IN THE UNITED STATES DISTRICT COURT  
FOR THE EASTERN DISTRICT OF NORTH CAROLINA  
WESTERN DIVISION  
No. 5:21-cv-00395-M

**INDEX OF CONSENT ORDER EXHIBITS**

Milburnie Road Matrix of Required Retrofits to Public and Common Use Areas.

# MILBURNIE ROAD APARTMENTS: PUBLIC AND COMMON USE AREAS

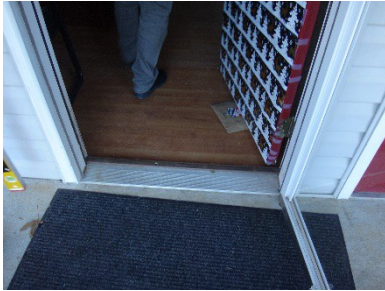
Numbers	Photos	Deficiency	Required Retrofit
	<b>Inaccessible Slopes at Routes</b>		
2	 <p><i>Measuring cross slope at turn to mail area.</i></p>	<p>Cross slopes of the routes/sidewalks are more than 2% (maximum 2% allowed).</p> <p>Location</p> <p>Southeast of Building 4                      7.2% (at curb ramp at Gibney Dr.)</p> <p>East of Building 4                      4.0% (at intersection of Gibney &amp; Sawpit)</p> <p>East of Building 4                      3.9% (route to leasing office)</p> <p>East of Building 4                      4.5% (route to leasing office)</p>	Modify 3.9%, 4.0%, 4.5%, and 7.2% cross slopes to comply with ANSI 4.3.7.

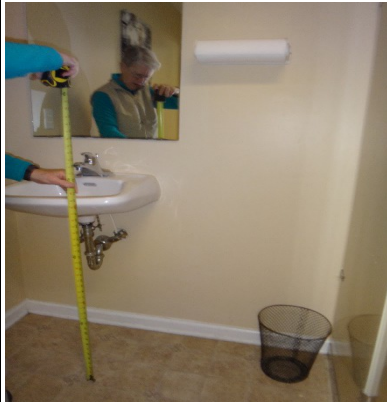
Numbers	Photos	Deficiency	Required Retrofit
23	 <p><i>Rear grab bar at men's restroom.</i></p>  <p><i>Height of rear grab bar.</i></p>	<p>Toilet grab bars are more than 36 inches above the floor (maximum 36 inches allowed by ADA, maximum 36-3/4 allowed by ANSI 1986).</p> <p>Grab bar Men's rear wall</p> <p>Height (inches) 37-7/8</p>	<p>Fix 37 7/8" to comply with ANSI 4.16.4.</p>

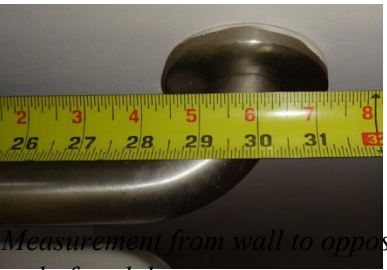
Numbers	Photos	Deficiency	Required Retrofit						
3	<div></div> <p><i>Curb ramp southeast of Building 2.</i></p> <div></div> <p><i>Measurement of running slope.</i></p>	<p>The running slope of the curb ramp is more than 8.3% (maximum 8.3% allowed).</p>

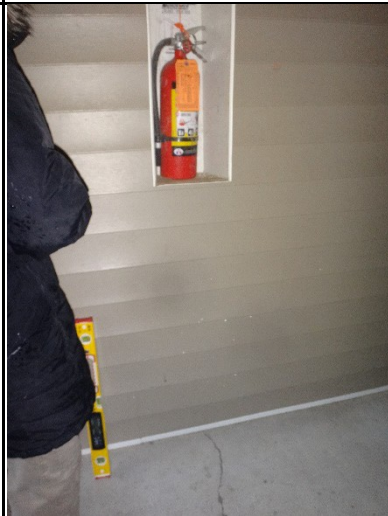
Numbers	Photos	Deficiency	Required Retrofit
9	 <p><i>Trash/Recycling area adjacent to Building 3</i></p>  <p><i>Looking toward car care center from Building 3.</i></p>	There is no accessible route between unit entrances and common use areas (accessible route required).	Fix to comply with Requirement 2.
	<b>Inaccessible Changes in Level</b>

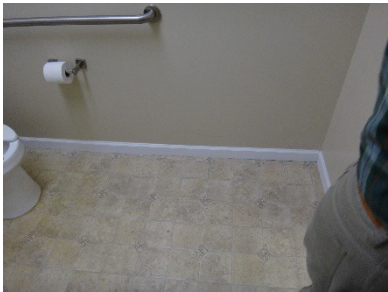
Numbers	Lack of Accessible Route	Deficiency	Required Retrofit
1	 <p><i>Route along drive lane.</i></p>	There is no accessible route between pedestrian site arrival points and leasing office.	Install accessible sidewalk to Rollinwood Drive to the South.
	<b>Inaccessible Parking Features</b>		
2	 <p><i>Parking aisle location.</i></p>	Designated parking access aisle at leasing has a running slope greater than 2.0% (maximum 2% allowed).	Modify 3.9% running slope to comply with ADA 4.6.2.

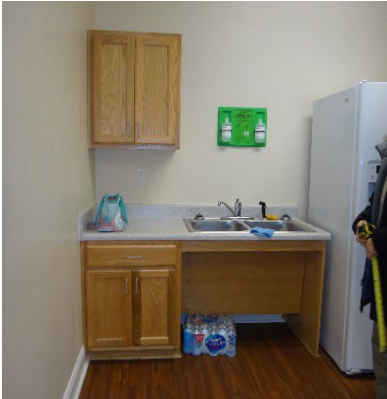
Numbers	Inaccessible Brochure Holder	Deficiency	Required Retrofit
1	 <p><i>Brochure holder.</i></p>	The brochure holder is 55-1/2 inches above the floor (maximum 54 inches allowed).	Relocate brochure holder to comply with ANSI 4.2.6.
<b>Inaccessible Restroom Features</b>			
2	 <p><i>Height of coat hook in women's restroom.</i></p>	The women's restroom coat hook is more than 56-1/2 inches above the floor (maximum 54 inches allowed).	Modify coat hook to comply with ANSI 4.2.6.

## **West Oaks Accessible Route and Key Plan**

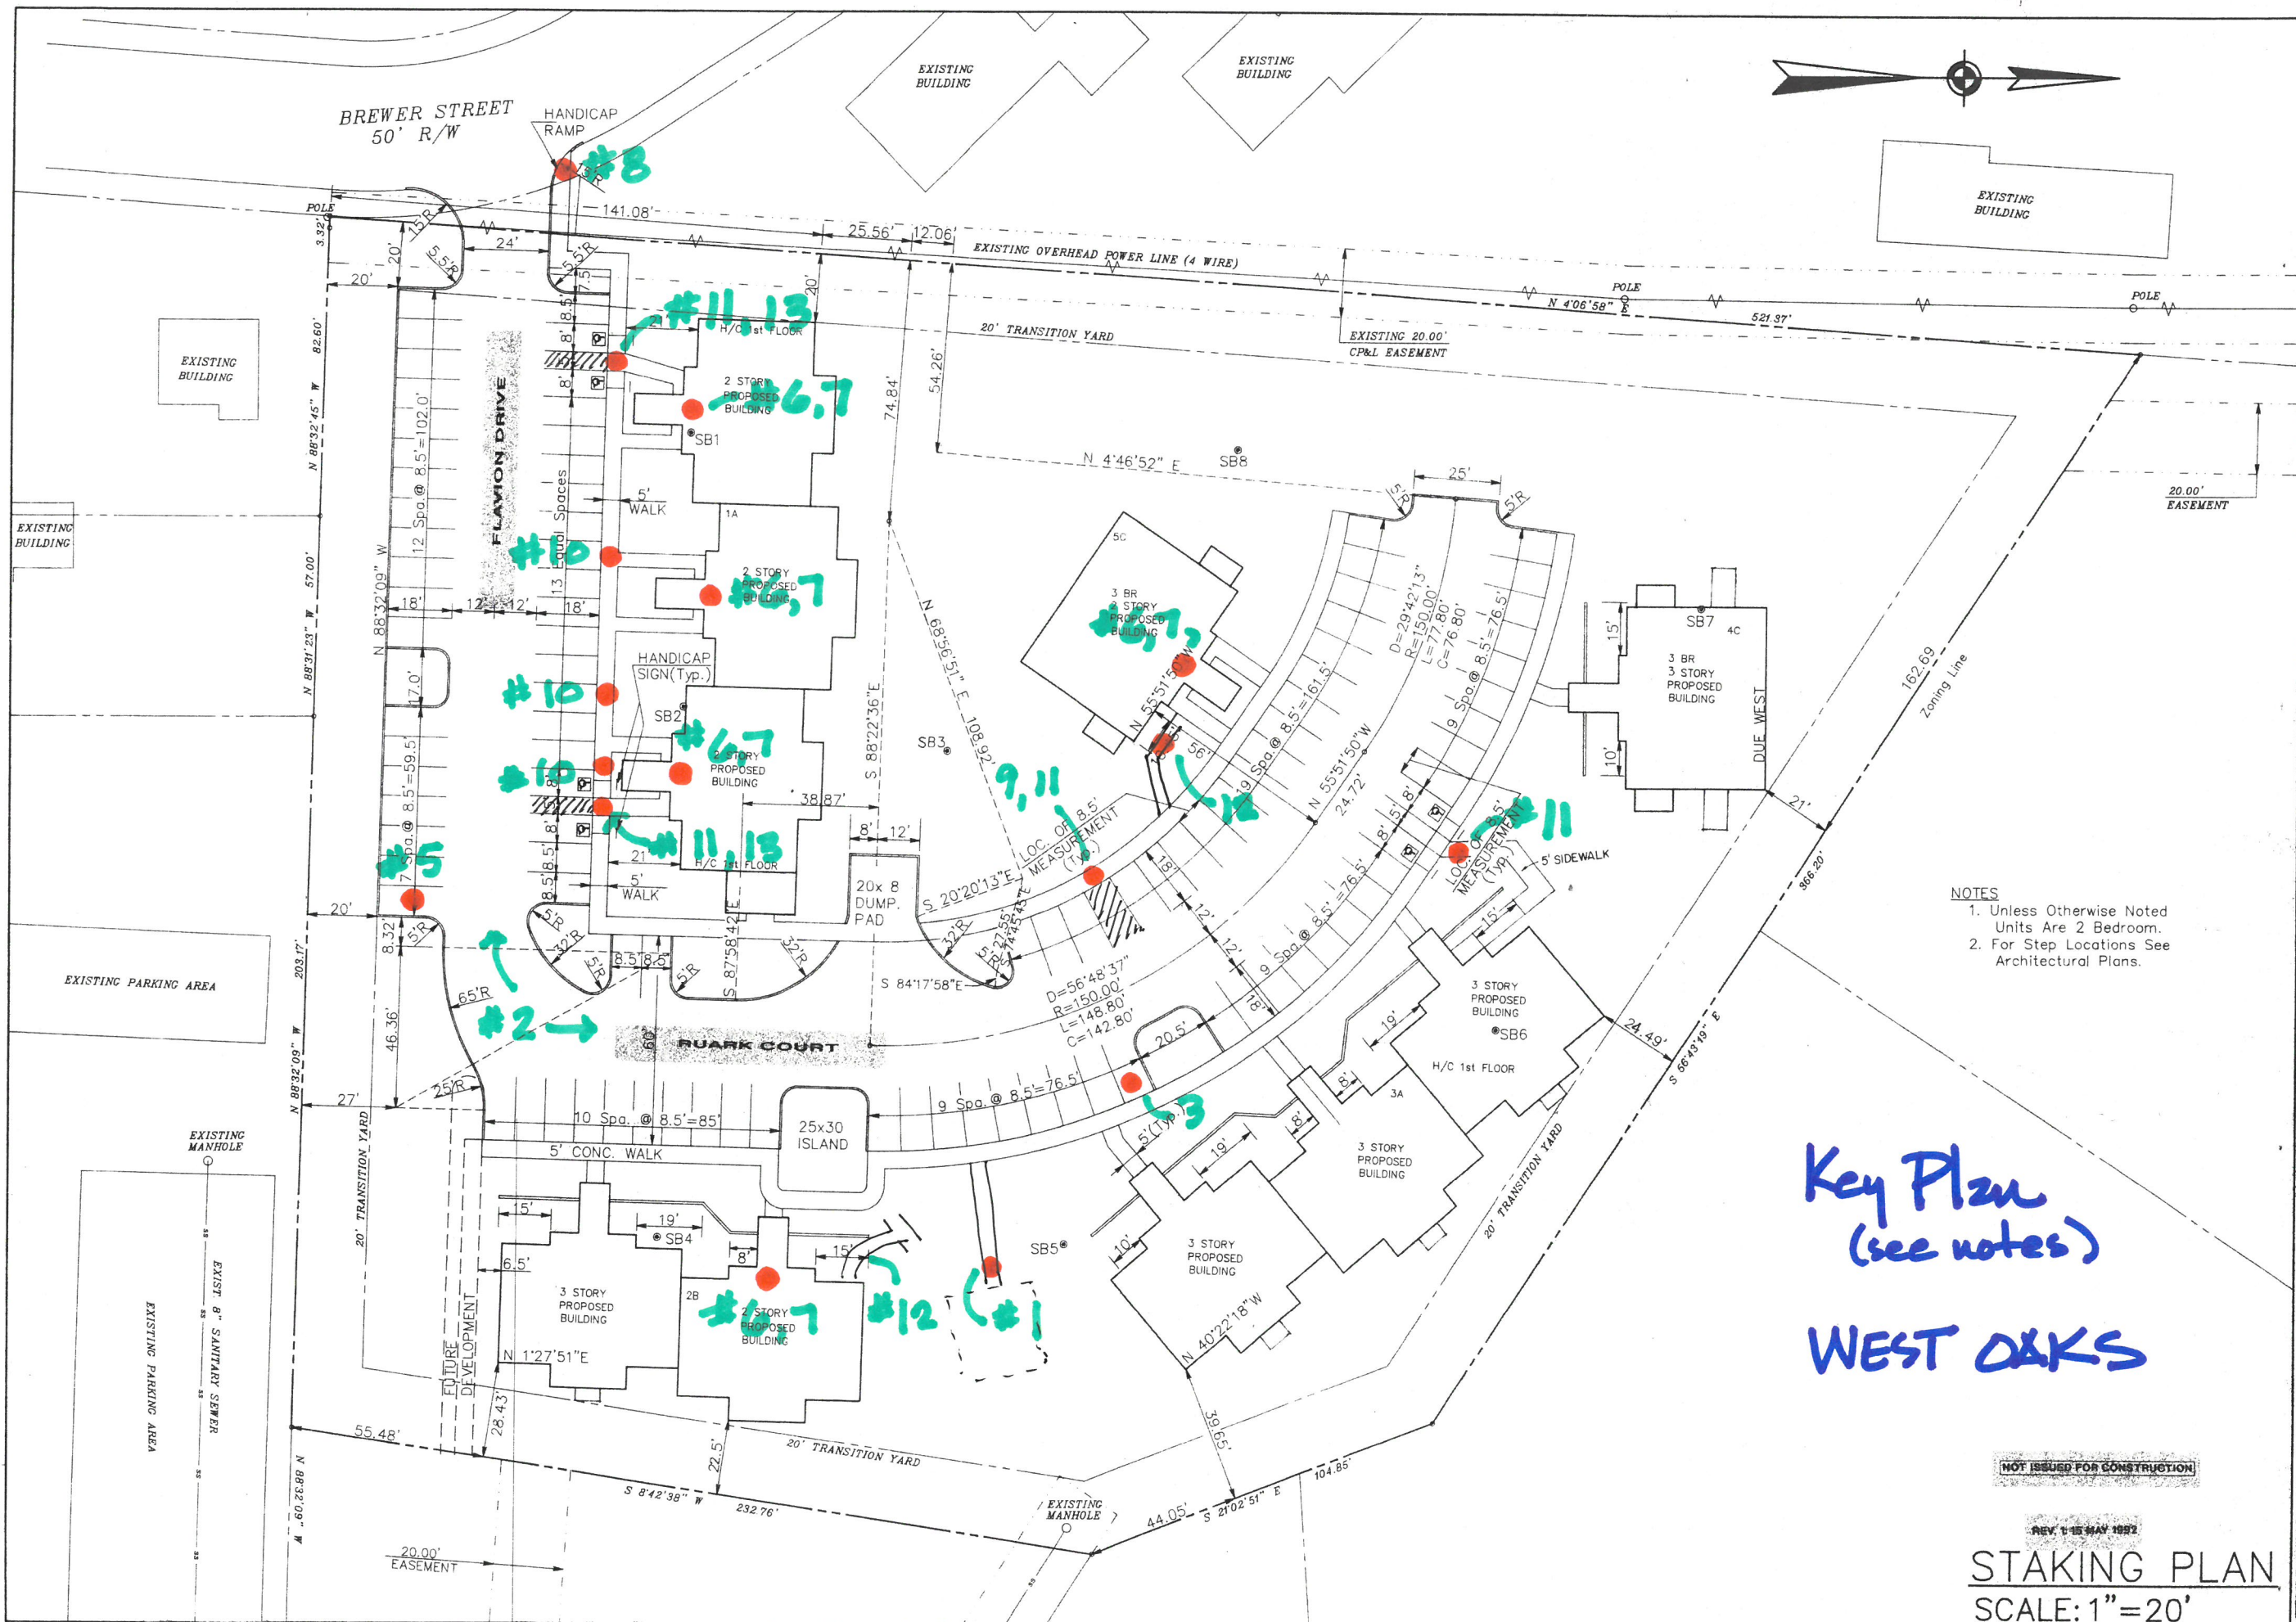
<b>Numbers</b>	<b>Photos</b>	<b>Deficiency</b>	<b>Required Retrofit</b>
2		Parked vehicles overhang and reduce the width of an accessible route to less than 36" wide maximum.	Install wheel-stops at parking spaces which adjoin the accessible route as indicated on the Accessible Route Plan to comply with ANSI 4.3.
3	See Accessible Route Plan and Key Plan.	There is a lack of accessible parking along the accessible route on the east side of the property.	Provide one new parking space on the east side of the complex. Space must be on the accessible route serving Building 2100 and the play area. See Key Plan #3 for proposed, not mandatory, location. Stripe a crossing to the accessible parking.

Numbers	Photos	Deficiency	Required Retrofit
4		There is no permanent accessible route to Building 2117.	Install a permanent and compliant accessible route to Building 2117. See Accessible Route Plan for location.
5	See Accessible Route Plan and Key Plan.	There is a lack of accessible parking at the recycling center.	Install an accessible parking space at the recycling center. See Key Plan #5 for location. Alternatively, relocate the recycling center to a compliant location.

<b>Numbers</b>	<b>Photos</b>	<b>Deficiency</b>	<b>Required Retrofit</b>
8		At the entrance to West Oaks at Brewer Street, the curb ramp has cross slopes exceeded 2% maximum.	Modify curb ramp to comply with ANSI 4.7.2 and 4.8.2 contingent upon approval from the City of Raleigh.
9	See Accessible Route Plan and Key Plan.	At between the dumpster pad and Building 2117/unit 101, the in-line curb ramp has cross slopes greater than 2% maximum.	Modify curb ramp to comply with ANSI 4.7.2 and 4.8.2.
